Reply to Referee #1

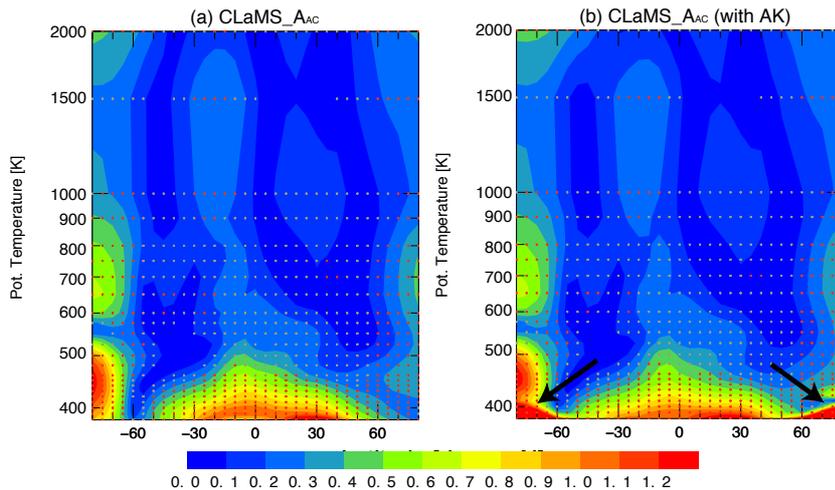
12. p6 l12-15: It seems important not to ignore the fact that the MLS weighting functions do not only produce 'artefacts' when applied to the CLaMS output, but that these artefacts may also be part of what is presented as the MLS observation - i.e. the MLS observations imply vertical structure that may be quite

different to what is actually present. (At least that was my interpretation of Ploeger et al 2013.)

*It is true. We compared the differences between CLaMS results of AC amplitude with and without application of AK (see the figure below). The differences are only visible in high latitudes at lower stratosphere. Similar result is shown in Ploeger et al 2013.*

*The region showing differences (high latitudes at lower stratosphere) are not the main concern in this paper.*

*We made a note at Page 6 line 23-24.*
